URGENT SAFETY RECALL

SUBJECT: Precedent Golf Car and Transportation Vehicle Hub Nut Campaign

Precedent Front Spindle and Hub Torque Check Procedure

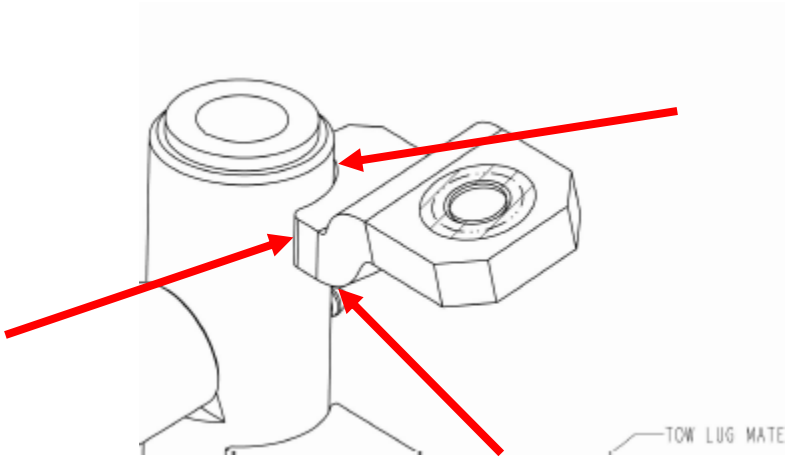
- Inspect spindle steering arm for complete weld across top, bottom and sides. See illustration below.

- If weld does not go completely around the steering arm, replace spindle as specified in the corresponding maintenance and service manual.
- If welds are within acceptable limits, mark spindles with a check mark √using a paint pen.
- Carefully remove wheel covers from wheels.
- Using a marker or paint pen, mark a line along the bolt and nut joint on both sides of the vehicle.
- Using a calibrated torque wrench with a 21mm socket, apply 60 ft-lb (81Nm) of torque to the hub nut joint on both sides of the vehicle.
- Visually inspect the mark to determine if the nut has moved.
    - If movement is detected, replace the wheel cover.
    - If no movement is detected, replace the spindle per the Maintenance and Service Manual.
        - Replacement parts are
            - 103638701 for Left side
            - 103638702 for Right side.
